WARRANTY BULLETIN SAFETY CAMPAIGN

Can-Am® On-Road Spyder™

October 8, 2024 Subject: **Engine Output Shaft Can Break - Potential Loss of Drive Power**

No. **2019-12**

TYPICAL – APPLY LOCTITE 5910 UNDER SCREW HEAD

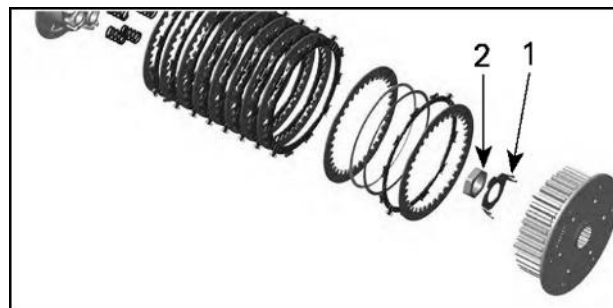
Clean previously removed screws using a steel brush then reuse. For the longer ones, apply sealant Loctite 5910 under the screw head surface all around.

1. Clean, apply Loctite 5910 under head and reuse.
2. Clean and reuse.

SERVICE PRODUCT
Loctite 5910 Sealing Compound

1. Tab washer included in kit
2. Clutch hub retaining nut included in kit

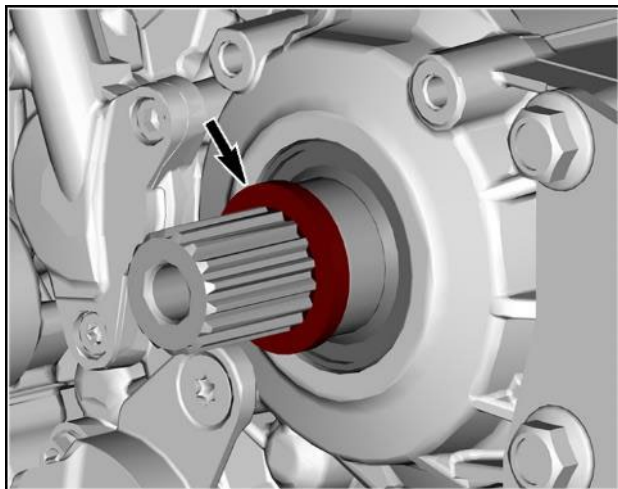
8. Reinstall Clutch. Refer to [CLUTCH \(SE6\)](#) or [CLUTCH \(SM6\)](#) Service Manual subsection. However install tab washer and clutch hub retaining nut included in the kit. Apply threadlocker on threads and tighten clutch hub retaining nut to **new** specification.

SERVICE PRODUCT
Loctite 648 (green)

TIGHTENING TORQUE	
Clutch hub retaining nut	190 N•m ± 10 N•m (140 lbf•ft ± 7 lbf•ft)
